SITE PLAN REVIEW AND APPEARANCE BOARD STAFF REPORT

Delray Dermatology – 802 SE 5th Avenue

Meeting	File No.	Application Type
September 24, 2025	2024-254	Level 2 Site Plan
Property Owner	Authorized Agent	
802 SE 5 th Ave LLC	Randall Stofft Architects

Consideration of a Level 2 Site Plan Application with Architectural Elevations, Landscape Plan, and a Landscape Waiver for a two-story, approximately 12,000 square foot commercial development with medical office and retail.

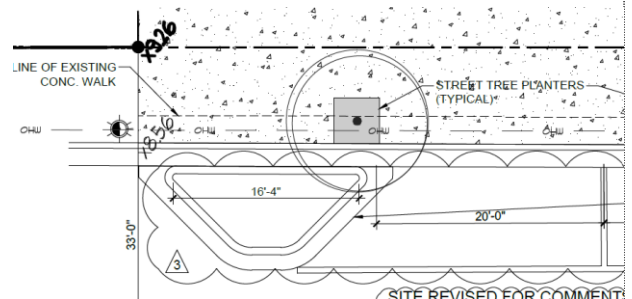
The project proposes a 16'4" landscape island at the SE corner of the development site whereas the LDR requires a minimum depth of 22' for islands. The reduction is predicated on the fact that, in order to extend the island to 22', the island would be required to extend beyond the subject property line. However, the drive-aisle curb cut providing access to the adjacent property is located close to the property line such that an extension of the island beyond the proposed 16'4" is not feasible. Alternatively, one of the proposed on-street parking spaces could be removed to allow for the full

extent of the 22' island to be placed adjacent to the subject property. However, both staff and the applicant agree that the additional parking space is a net benefit that justifies the provision of a 16' island, as the intent of the regulation is still met.

Staff has no issue with the requested landscape island reduction.

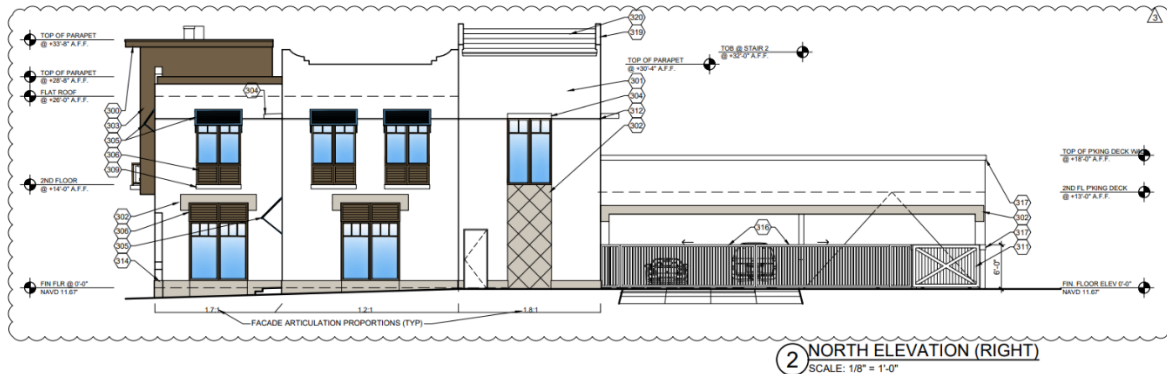
The composition maintains compliance with established façade proportion ratios that allow the building to maintain consistency with the historic downtown scale, and the design successfully incorporates a tripartite composition on the primary street elevation where a clear base, middle, and top of the composition is defined on the two-story structure. However, the side facades lack a defined tripartite element.

Specifically, staff finds that the north elevation facing the secondary street provides a defined base, with the projected masonry stone base, while the middle and top are not clearly differentiated. The Board shall consider whether the intent of the regulation is met or if improvements are necessary on the secondary facades so that they also convey a clear tripartite composition.
